PLANNED UNIT DEVELOPMENT

& SUBDIVISION STAFF REPORT Date: November 1, 2012

DEVELOPMENT NAME Lee Vella Subdivision

CONTEMPLATED USE Planned Unit Development Approval to allow a private street commercial subdivision and Subdivision approval to create four legal lots of record from an existing legal lot of record.

SITE PLAN

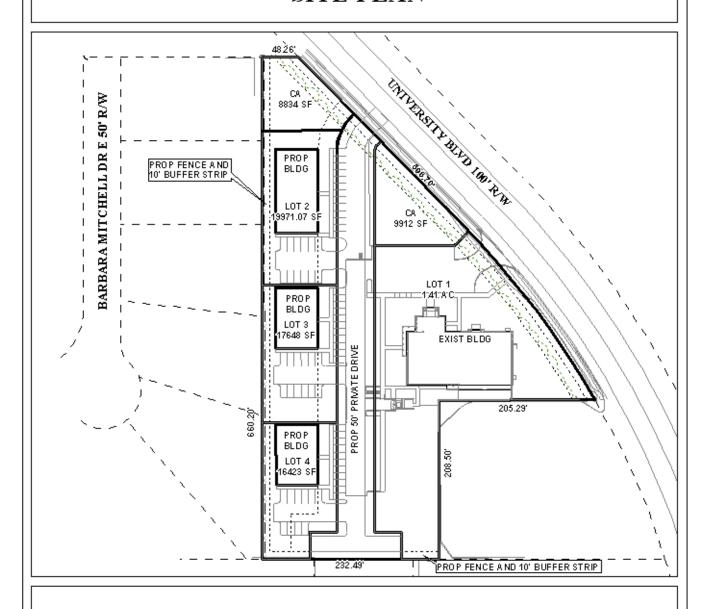
The proposed lots, as depicted, meet the minimum size and frontage requirements as regulated by the Subdivision Regulations. The 25-foot minimum building setback lines are not depicted; therefore, the plat should be revised to depict the 25' minimum building setback line along the private street frontage of all lots, if approved. The lot area sizes in square feet/acres are depicted on the preliminary plat and should be retained on the Final Plat, if approved.

An existing city standard sidewalk is indicated along the South University Boulevard; however, no sidewalks are illustrated along the private street. In addition, the site plan does not indicate a dumpster or contain a note stating how trash pick-up is proposed. Therefore, the site plan should be revised to indicate a continuous sidewalk that serves the parking spaces within the private street right-of-way, a dumpster, in compliance with Section 64-4.D.9. of the Zoning Ordinance, with a compliant sanitary sewer connection, or a note should be placed on the site plan stating that trash collection will be curb-side pick-up or private pick-up service.

The plan does illustrate two common areas; if approved, the Final Plat should include a note stating that maintenance of the common area is the responsibility of the property owners.

The site does not illustrate the location or number of the tree planting requirements of the Ordinance. Therefore, a condition of approval should be required that the development comply with the landscaping and tree planting requirements of the Ordinance. In addition, frontage trees are required along the private street as well.

- 1) revision of the site plan to illustrate the 25-feet minimum building setback along all lots along the South University Boulevard and the Private Street;

- 2) revision of the site plan to provide a dumpster, in compliance with Section 64-4.D.9. of the Zoning Ordinance, and with a compliant sanitary sewer connection, or the placement of a note on the site plan stating that trash collection will be curb-side or via private pick-up service;

- 3) compliance with the landscaping and tree planting requirements of the Zoning Ordinance;
- 4) labeling of any required detention area as common area and the placement of a note on the site plan stating that the maintenance of the common area is the responsibility of the property owners;
